STATE OF DELAWARE
OFFICE OF MANAGEMENT AND BUDGET
OFFICE OF STATE PLANNING COORDINATION

RE: PLUS review – 2025-05-05; Tappahanna at Watson Farm

Thank you for meeting with State agency planners on May 28th, 2025, to discuss Tappahanna at Watson Farm. According to the information received, you are seeking review of a proposed site plan for a concept involving the development of 434 residential units, including multifamily buildings and townhouses.

Proposed Project Parcel Flood Concern

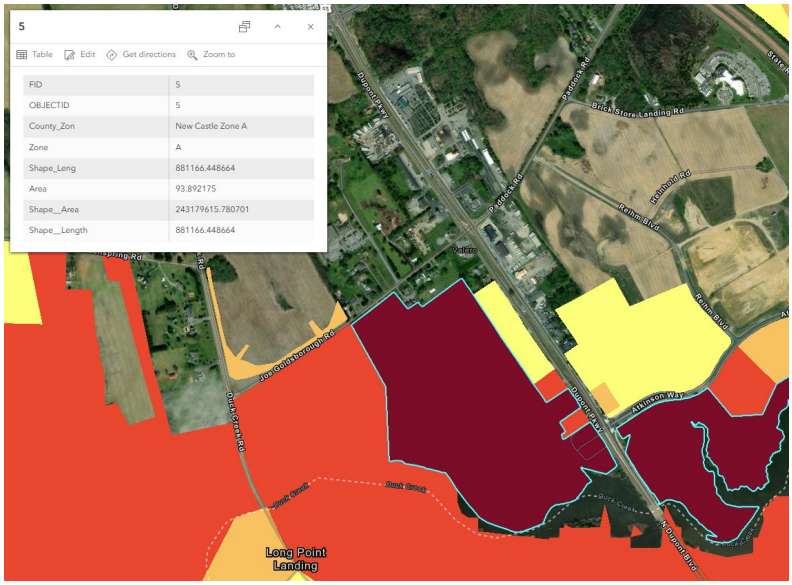
- The majority of this parcel is located within an area of **Minimal Flood Concern of 1,000 years or greater**, though there is the flood zone along the entire southern (into eastern

and western) portion of the parcel, which is identified in the submitted drawings with no construction occurring within the flood zone. Caution though is still advised when constructing near 100-year flood plains.
